SR 3/US 41/COBB PARKWAY WIDENING FROM PACES MILL ROAD TO AKERS MILL ROAD

STP00-0001-05(047), P.I. No. 721152

Value Engineering Study Report

March 2011

A.C.T. NO.
D-2
Sht. 2 of 8

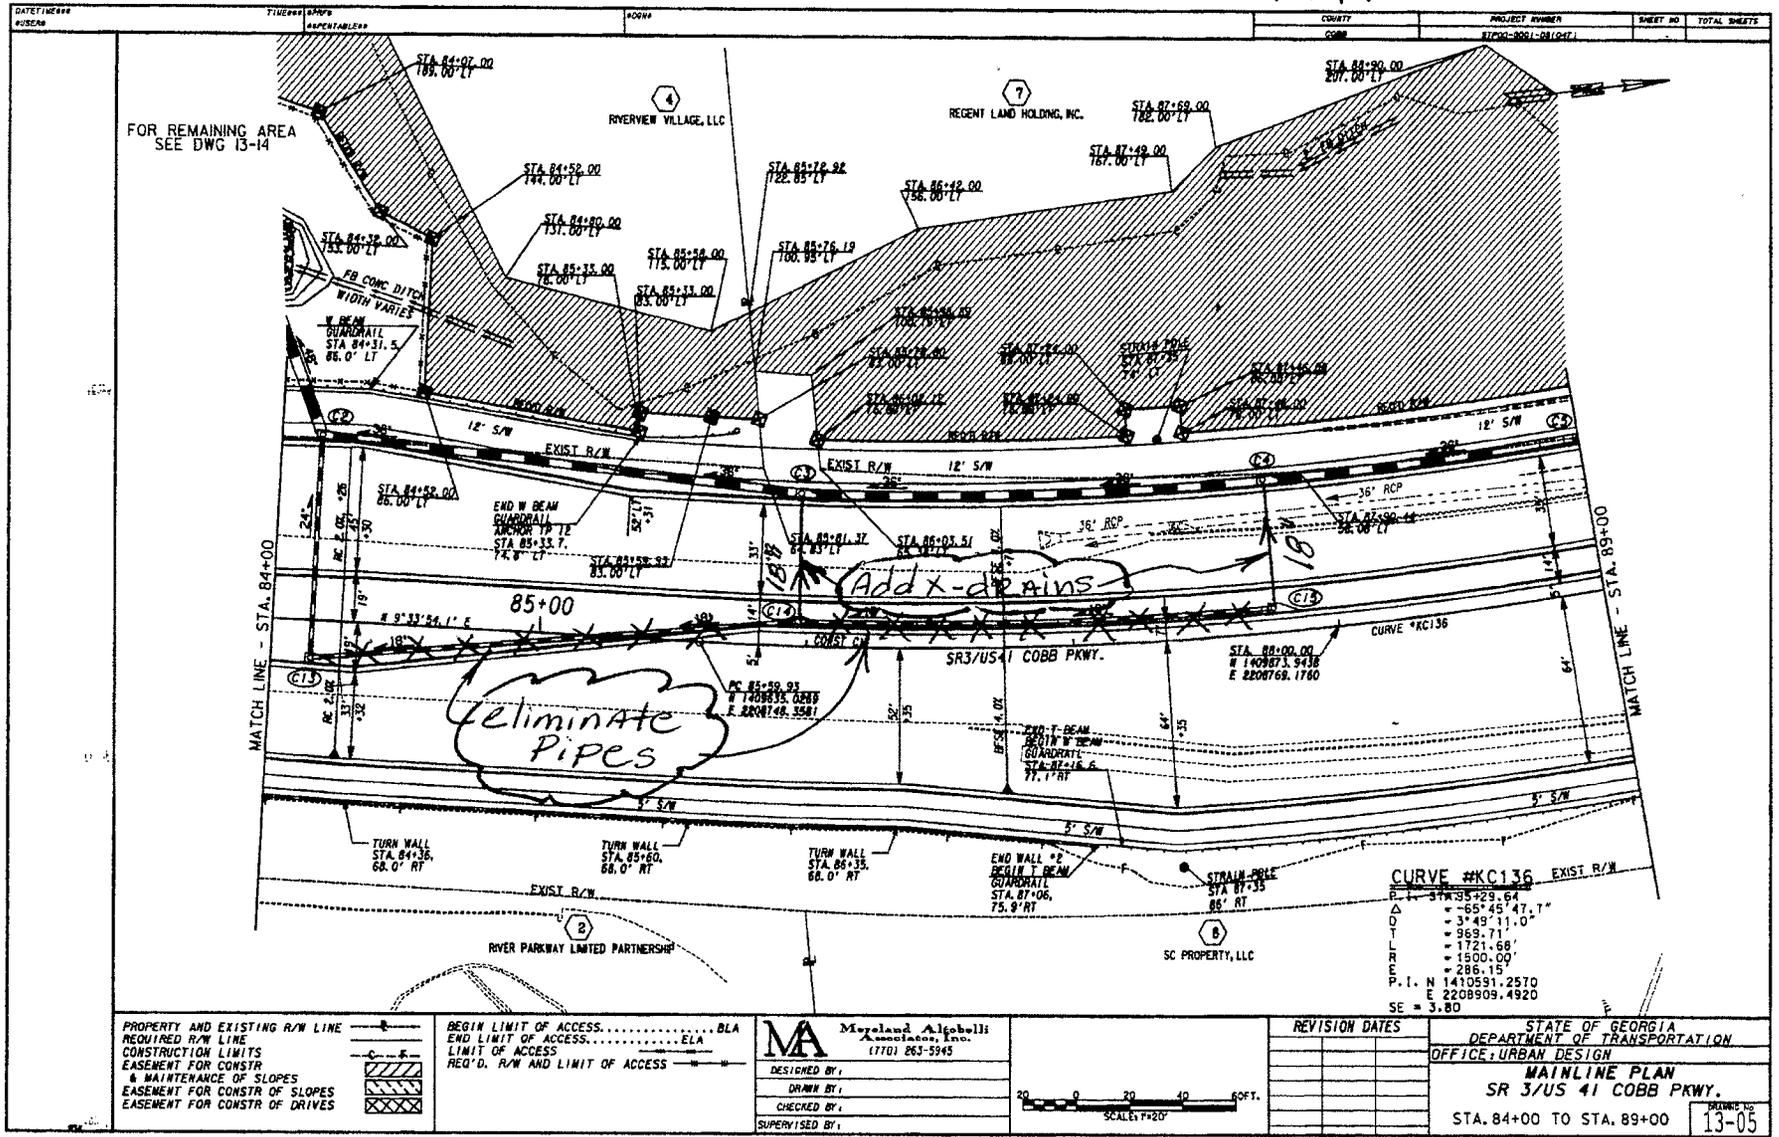
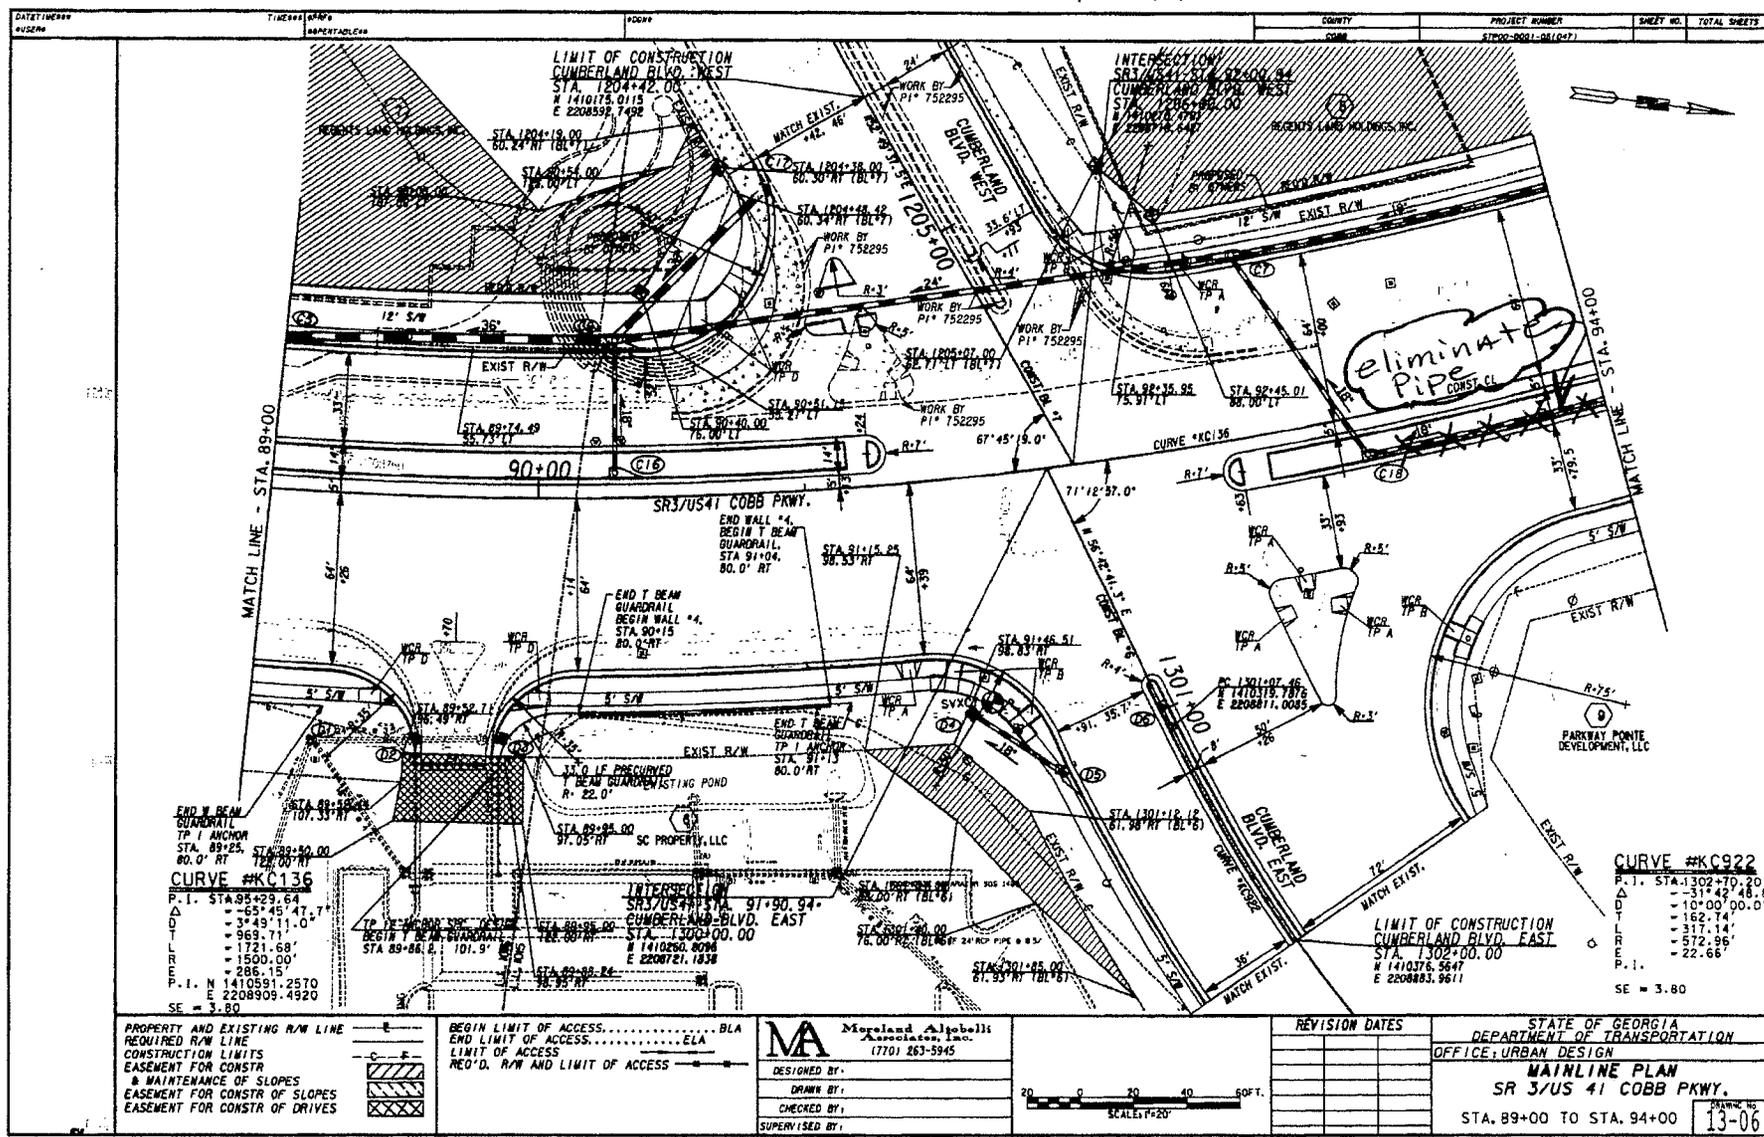
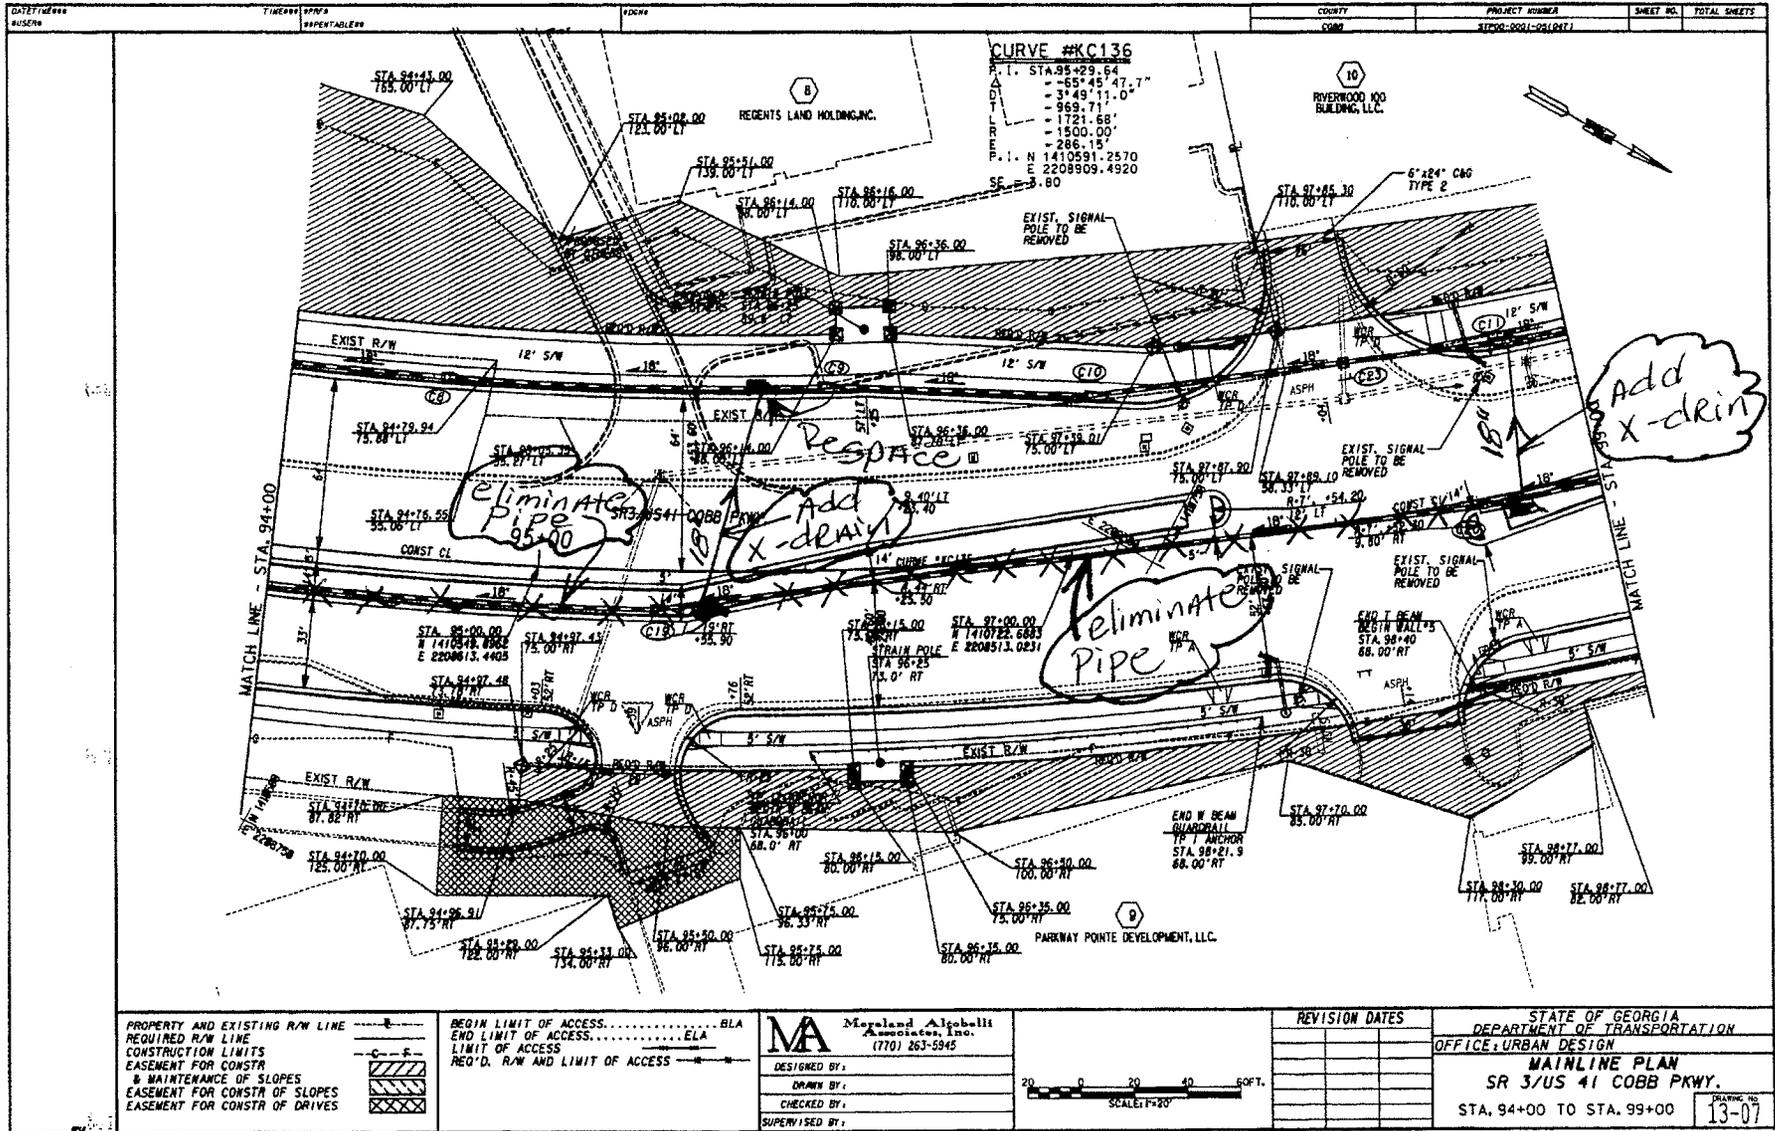
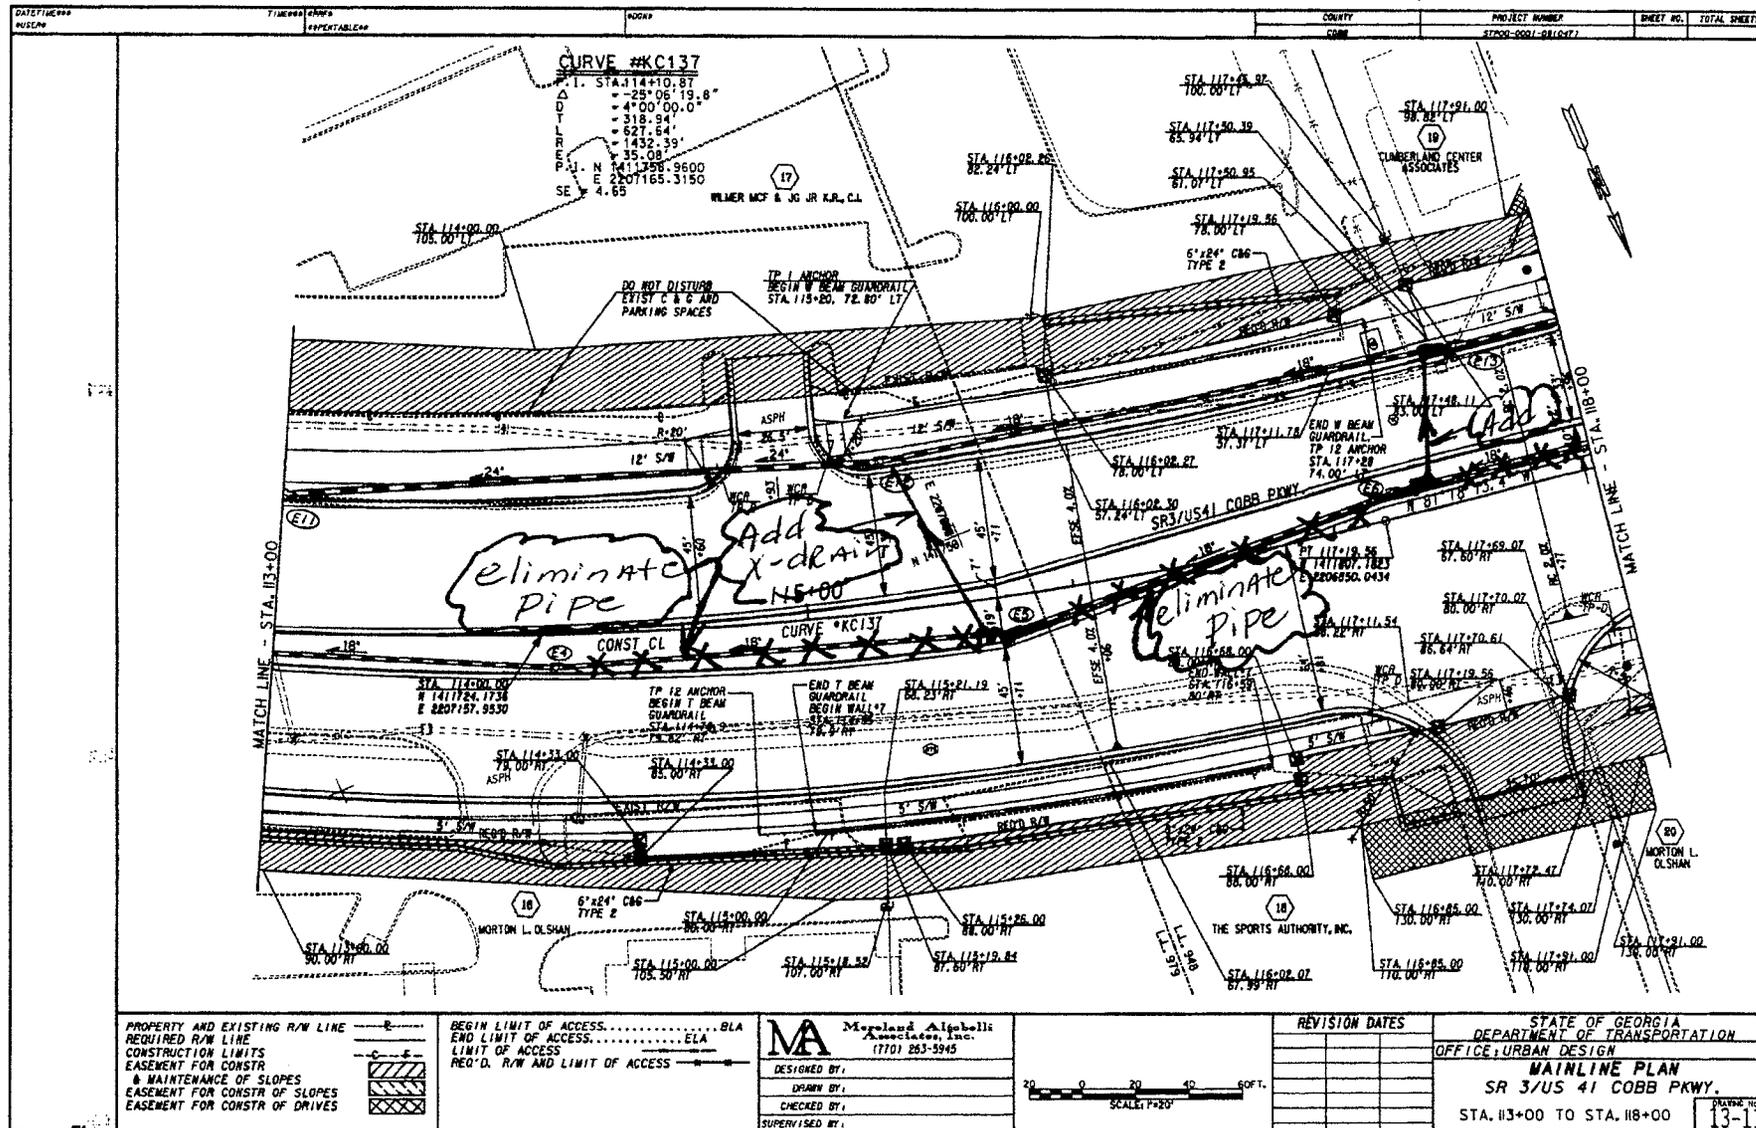
There are several long parallel runs of longitudinal pipe that could be drained into one system by using cross-drain pipes for structures in the median or located on the opposite side of the roadway. Since there would be one system under the alternate design, a portion of the pipe would increase in size.
